**FINDINGS AND RECOMMENDATION  
OFFICE OF PLANNING AND ZONING  
ANNE ARUNDEL COUNTY, MARYLAND**

**CASE NUMBER:** 2023-0166-V

**REQUEST**

The applicant is requesting variances to allow a lot with less width and area than required and greater density than allowed, and to allow a dwelling with less setbacks than required on property located at 1422 Brewer Road in Annapolis.

**DRAINAGE AREAS TO ESD FACILITIES**  
SCALE: 1" = 40'

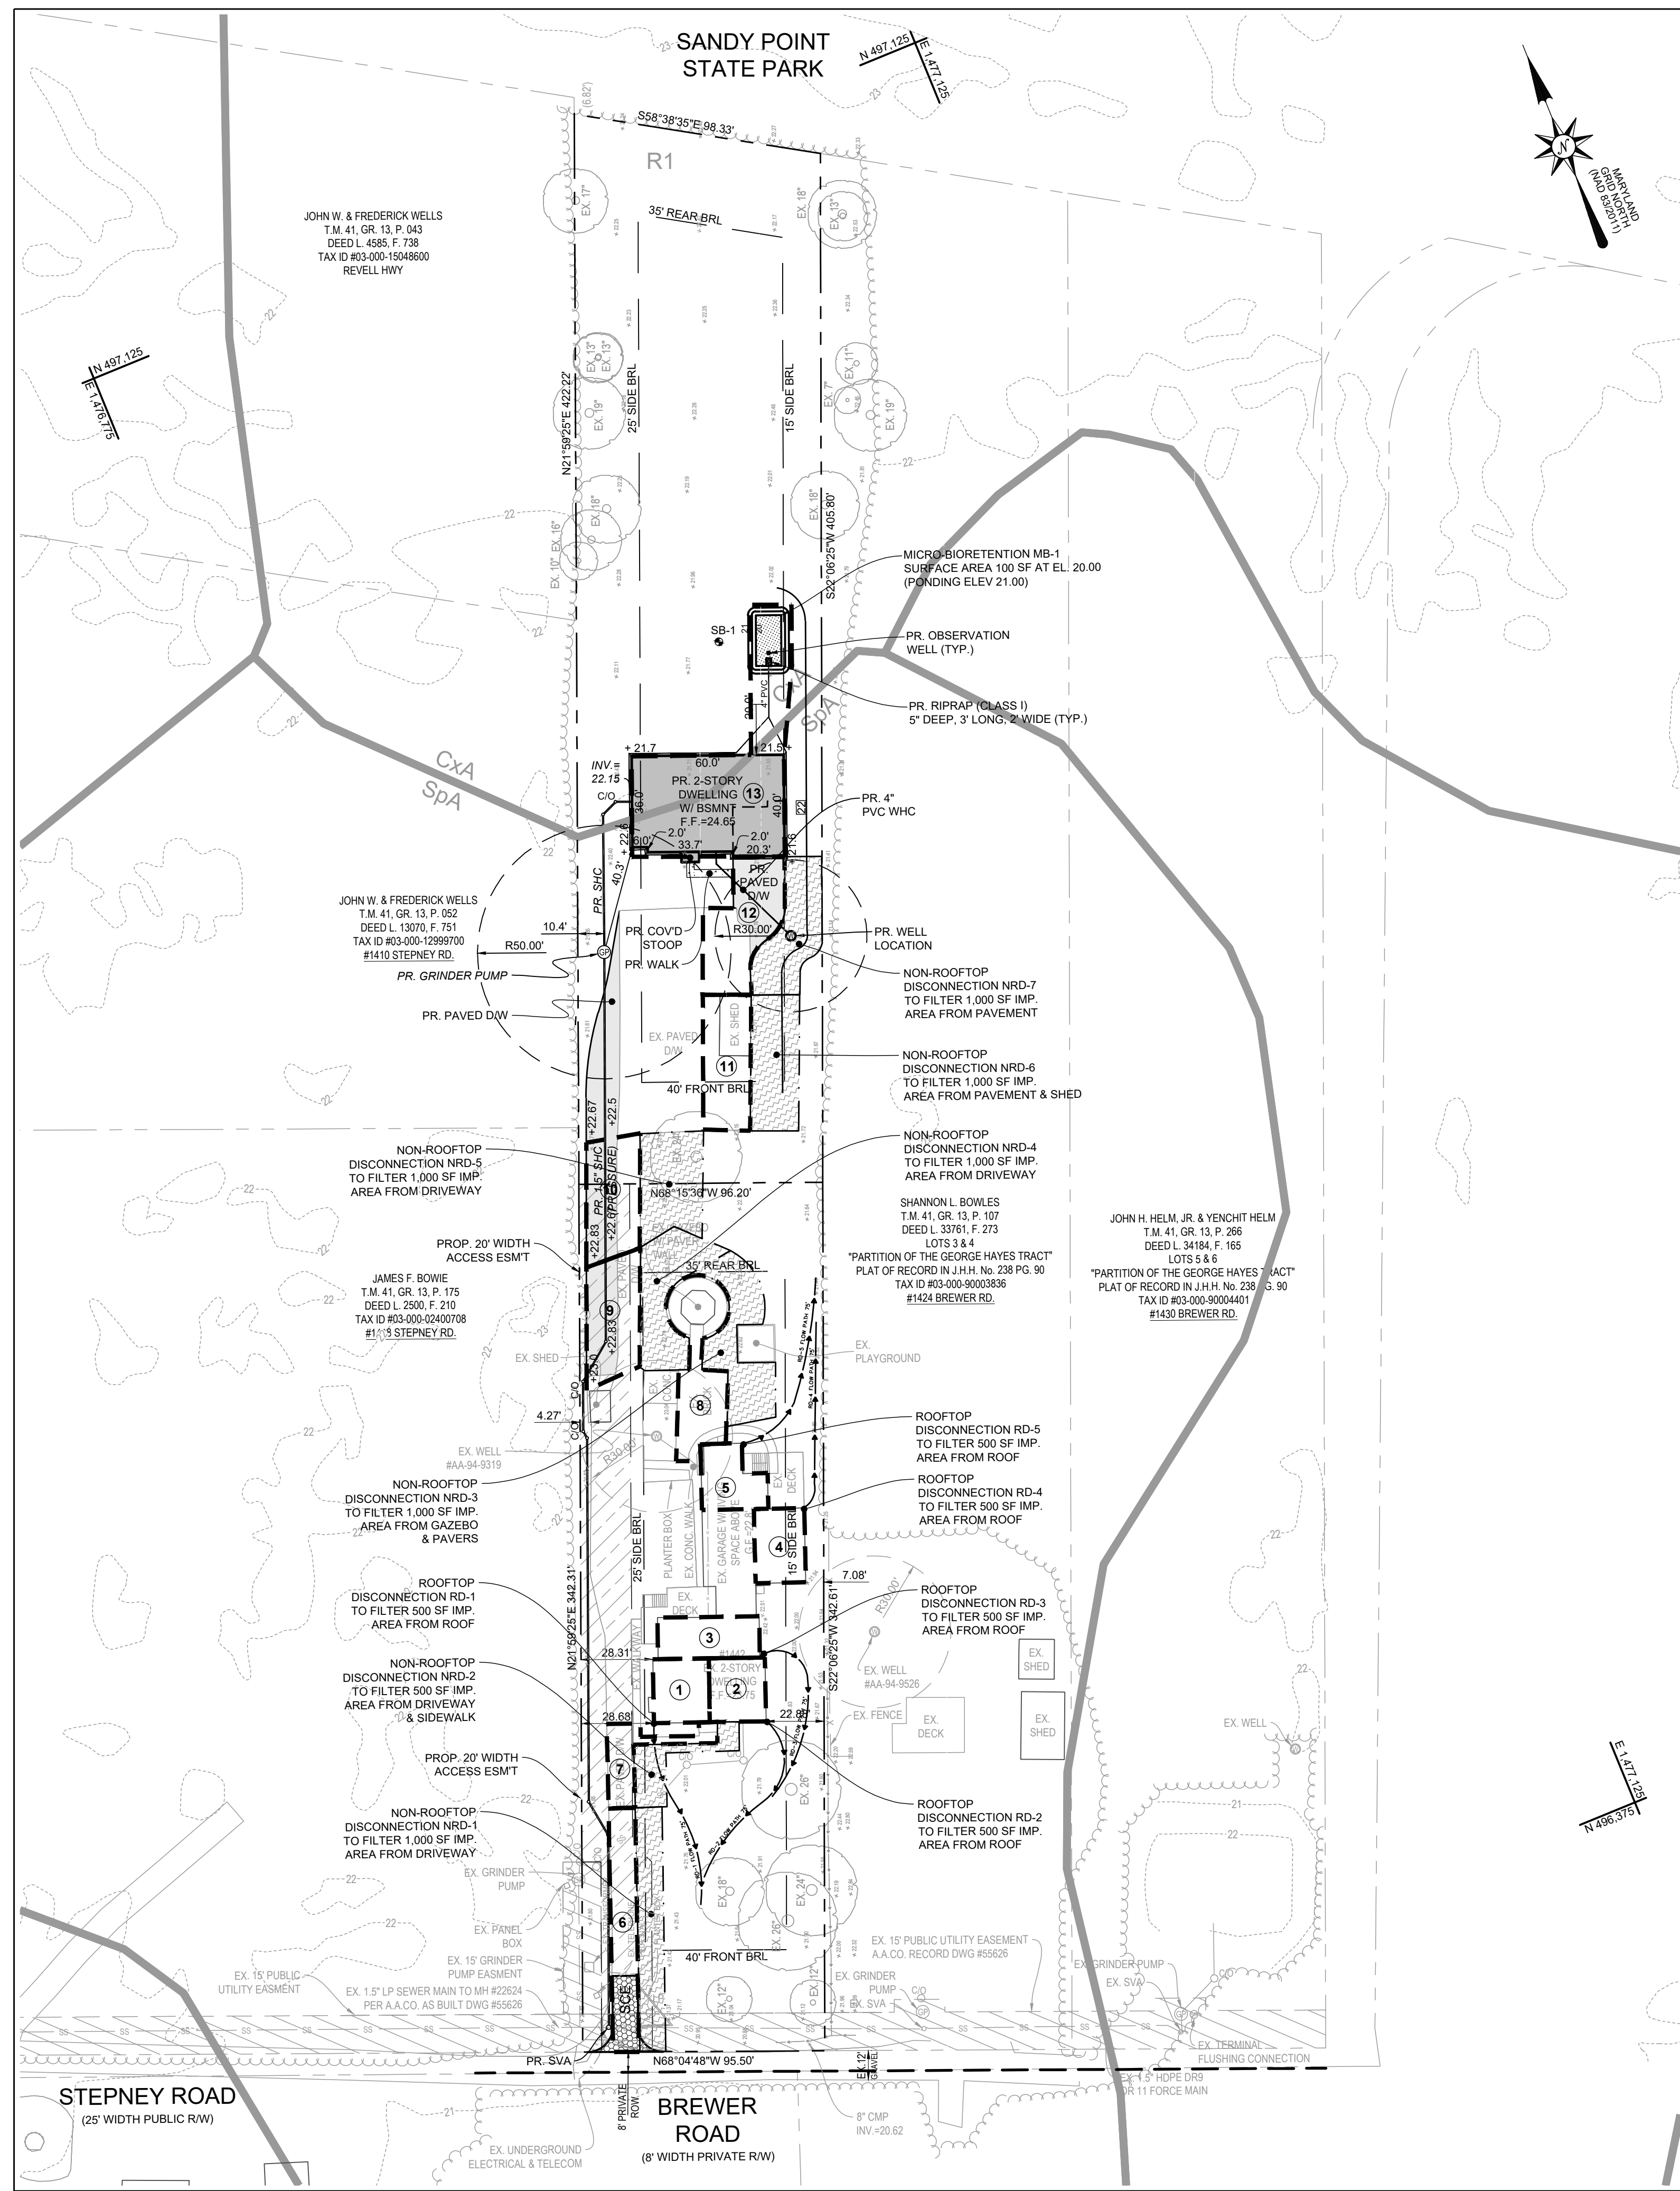
- The pre-file comments were not addressed. A SWM concept plan that addresses ESD to the MEP through site fingerprinting and reliance on conservation or nonstructural SWM practices for the entire site was not performed to show that the subdivision of the site can be achieved without reliance on micro-structural practices.

1- SWM must meet ESD to the MEP based on the overall site. Based on COMAR criteria, the site is defined as continuous parcels that are owned by the same entity or being considered as part of a development plan. The SWM report, which will be required to approve the new proposed lot reconfiguration, needs to provide site fingerprinting and explore conservation first, then minimization of imperviousness, then non-structural practices (alternative surfaces, disconnections, and sheet flow to the protected area". Reliance on micro-practices changes the sheet flow pattern and places a maintenance burden on future homeowners and should be avoided to the extent practical.
